DEFENSE NUCLEAR FACILITIES SAFETY BOARD

December 1, 2021

Staff Report

Alternate Location for the Co-Located Worker at the U1a Complex

Figure 1. *Aerial view of the U1a Complex and Area 6 construction facilities*

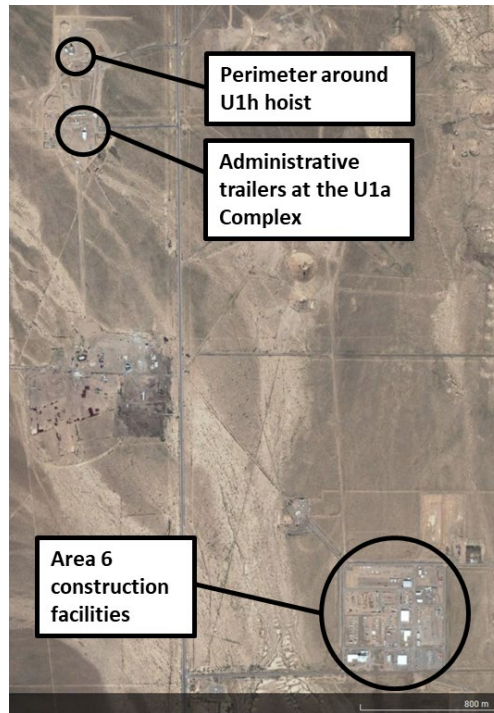
For example, even if the guidance in DOE Standard 3009-2014 were applicable to the major modification projects at the U1a Complex, the staff team concludes that moving the assumed location of the co-located worker to the Area 6 construction facilities is inappropriate. This location is approximately 3,500 meters from the U1a Complex and fails to take into account workers located in the administrative trailers or parking lot at the U1a Complex, which are

approximately 400 meters from the U1h hoist (location where the subcritical experiment package is lowered into the facility). In addition, MSTS plans to replace the administrative trailers by constructing two new support buildings at the U1a Complex to support the expected increase in personnel due to the expansion of the programmatic mission at the facility [12]. Figure 1 below highlights the distance between the U1a Complex and the Area 6 construction facilities.

NNSA personnel informed the staff team that the individuals in the administrative trailers or at the parking lot can be considered facility workers because they are trained to respond to the different emergency scenarios at the U1a Complex. However, DOE Standard 3009-2014 defines a co-located worker as a worker assumed to be located “at a distance of 100 meters from a facility (building perimeter) or estimated release point.” Therefore, the population of co-located workers includes individuals in the U1a Complex who are 100 meters away from the building perimeter where the release occurs. Also, DOE Standard 3009-2014 does not exclude an individual from consideration as a co-located worker based on their training to respond to emergency events.
